ENDEAVOUR HIGH RISE JULY 2022

ENDEADOUR **MOTHRA OUERUIEW JULY 2023**

ENDEAUOUR
RC SOUTH
OUERUIEW
JULY 2023

OCEAN NETWORKS CANADA ENDEAUOUR RIDGE FLANK OUERUIEW JULY 2023

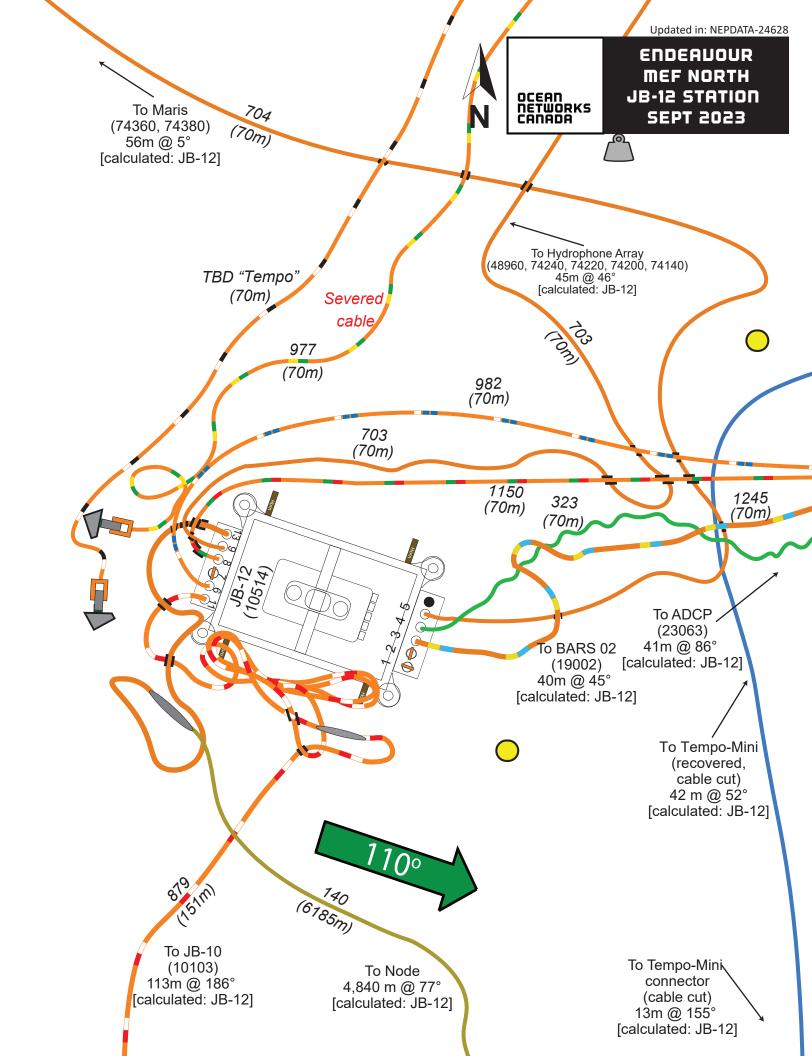
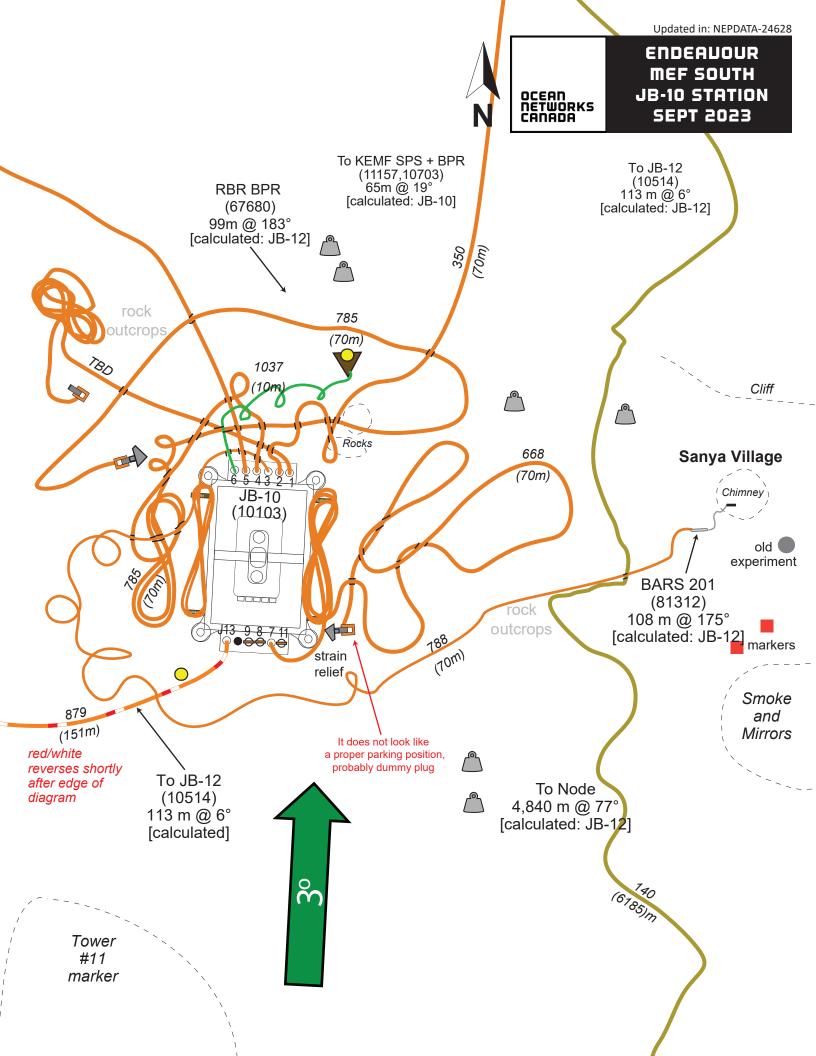
Updated in: NEPDATA-24628 iments: If time allows, more flying along the cables is required (JB-12 and Grotto) If time allows, more flying around mudmat required. Blue milk crate contains rigging attachments Cable 977 is severed ENDEAUOUR MEF Cable 1216 is severed
Can we clean up decomissioned/severed cables OCEAN NETWORKS CANADA OUERUIEW (recover some parts so it is less crowded?)

Please follow cable 982, as in the past updates the cable lay was partially missed and we need to update our records

Cable crossings along paths of 1245 and 1150 in some locations is questionable. If time allows it would be great to fly over the whole path in one run.

Can we fly around Sanya Village and Smoke and Mirrors? SEPT 2023 close to the hydrophone. No slack Cable is not recoverable. MudMat DP11 (44980) 260m @ 85° [calculated: JB-12] Hydrophone array (48960, 74240, 74220, 74200, 74140) 45m @ 46° [calculated: JB-12] depth: 2196m Gym weights (2x50lb) & blue milk crate bead bags (2 x 25lb)97m @ 42°[calculated: JB-12] BARS 02 (19002) 40m @ 45° 1390 (3m)[calculated: JB-12] depth: 2185m Maris & Interface Unit Camera System (24147,23073, 24105,27339) (74360, 74380) Danti **S** 56m @ 5° [calculated:JB-12] 46m @ 48° [calculated: JB-12] depth: 2190m "North Towe 704 (70m) Pillow lava bulbous (12.5m)rocks and mounds Easy to snag and p Cliffsuffoe outcrop cable Acquer's pass Falmat cable 991 severed on both ends (50m) Ciffsuffo outoo RAS/PPS (22799, 31519)Falmat (1216) 41m @ 86° [calculated: JB-12] depth: 2186m 1217 Tempo-Mini cable (end cut) 42 m @ 52° [calculated: JB-12] (3m)Maris cable (burried cut-off) **JB-12** (10514)52 m @ 77° [calculated: JB-12] 982 703 1245 depth: 2191m (70m) (70m) 399 (6.2km)

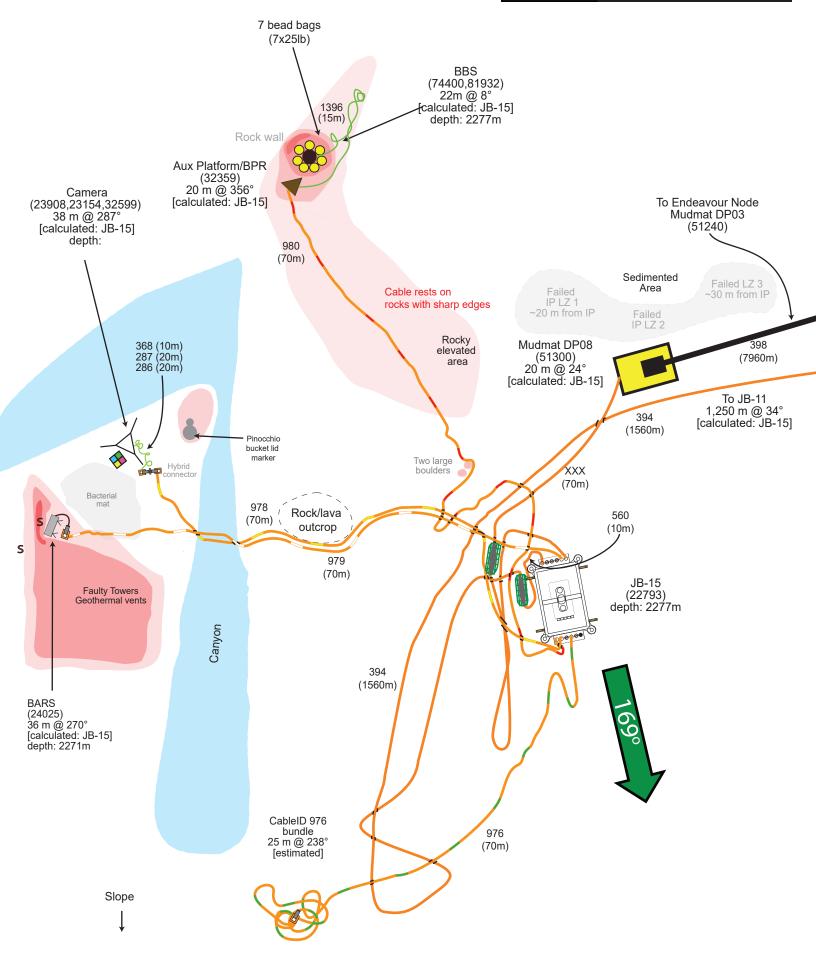
Site needs to be re-layed out. This diagram is stiched out of multiple dives, each one showing only small part of this site. Please fly over cables with ROV and JB-15. If time allows, more flying around mudmat required.

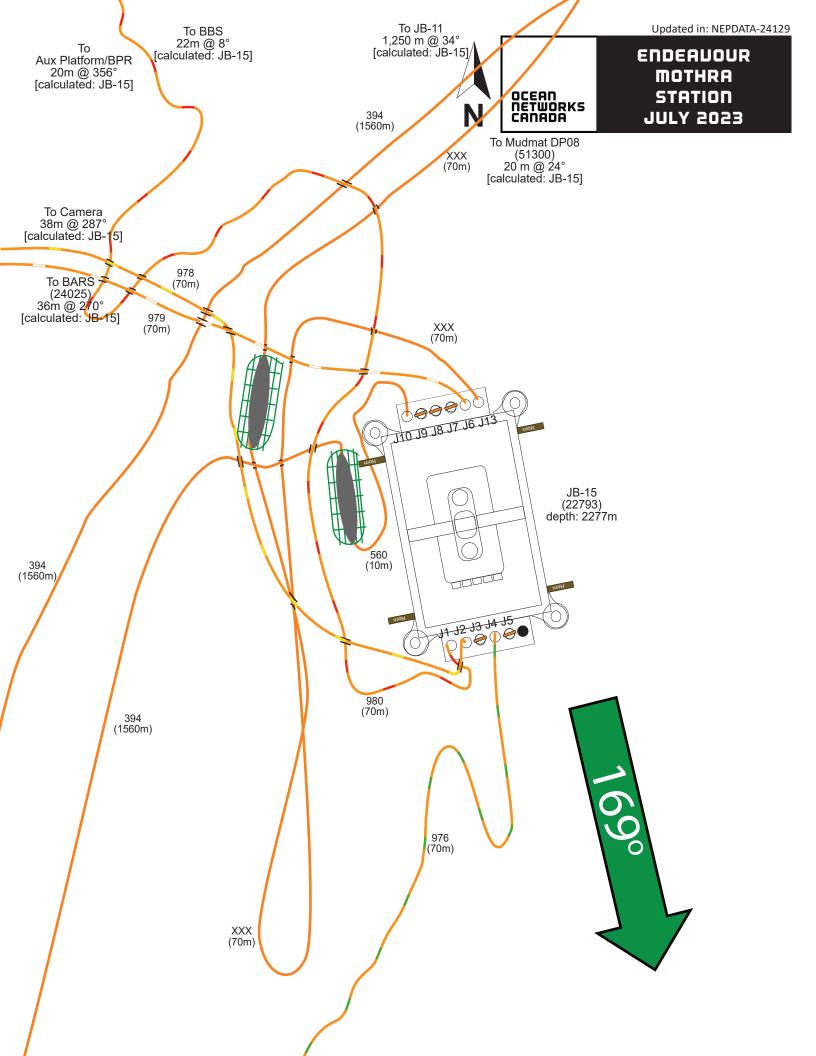
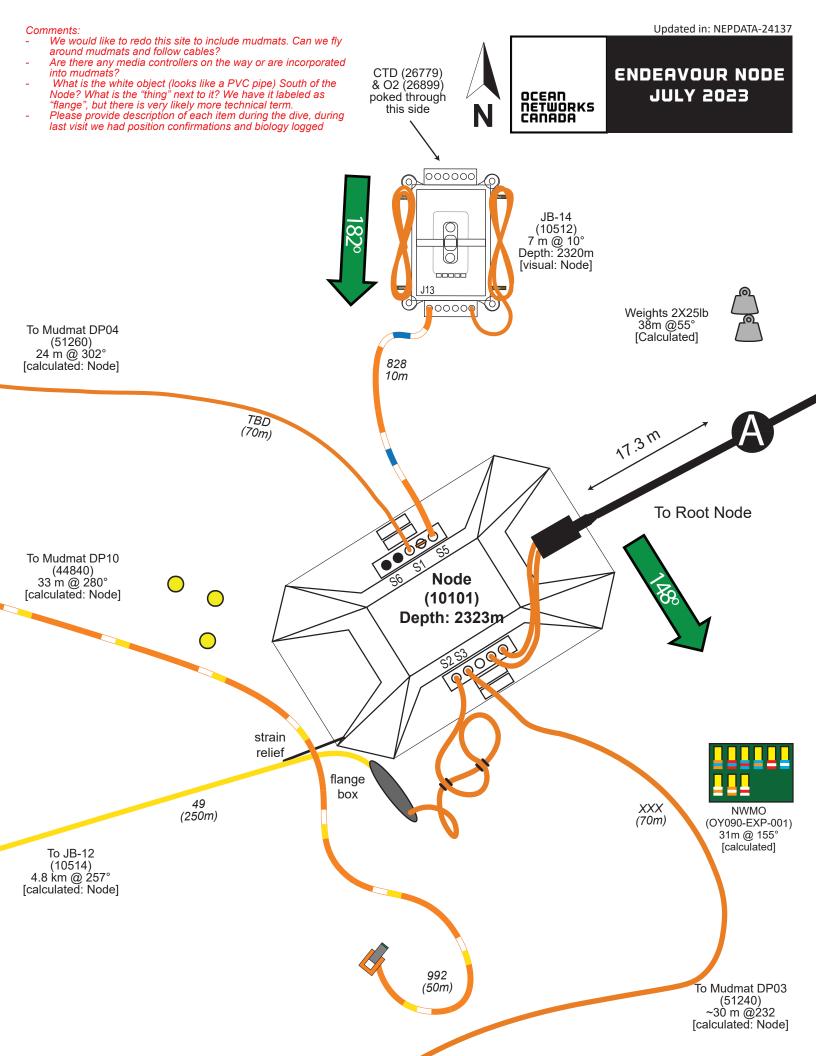
Media Converter and Mudmat (NEPDATA-23654)
Port J7 on JB-15 is faulty - very likely compromised It looks like there are two media converters on cable 560, but very likely the further one is rather on the cable that goes to Endeavour Node Mudmat Position confirmation for the mudmat

Position confirmation for the mudmat

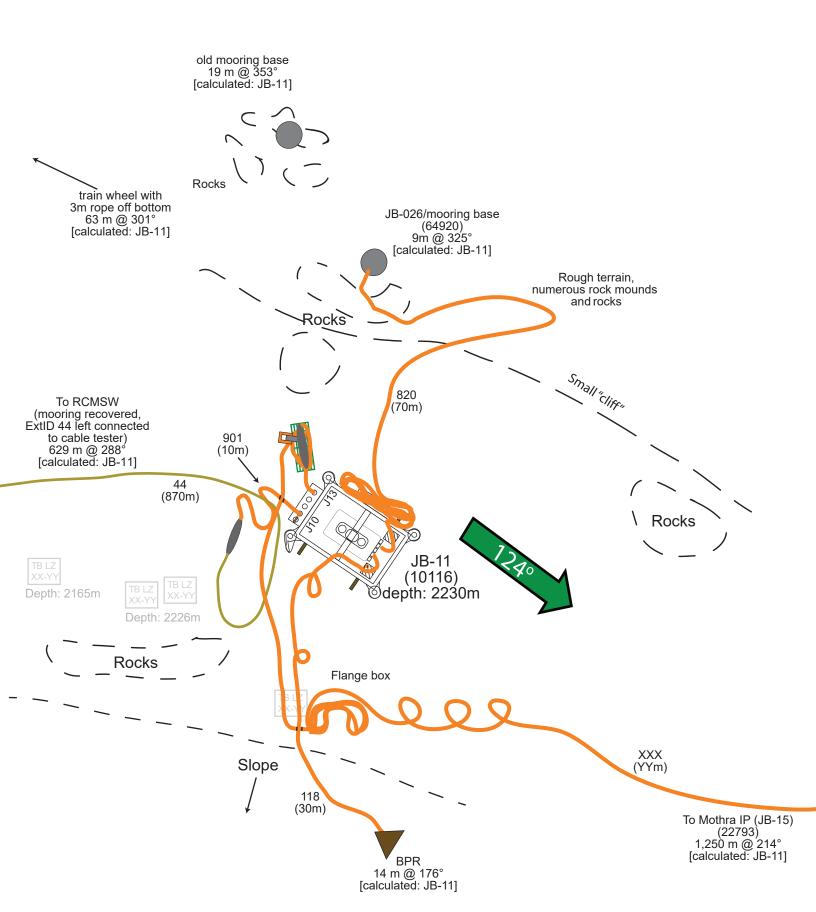
- Need to confirm coordinates of all devices due to observed position drift of 20m NE during Nautilus 2023-07.
- All distances were fixed with respect Aux Platform, not with respect to the mudmat.
